Questions:

IT Questions:

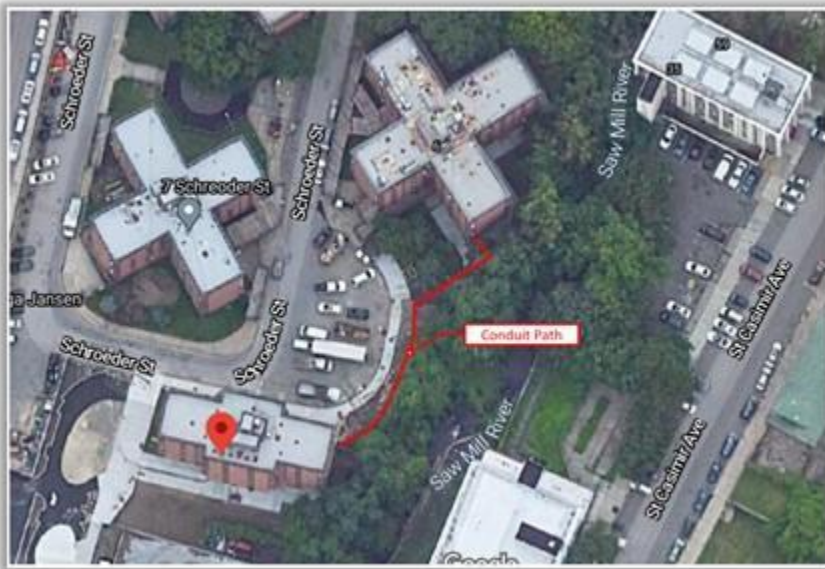
- -What type of enclosure should be used? (is there a specific size, rating, lock type, color that is required)

USE STANDARD ENCLOSURE
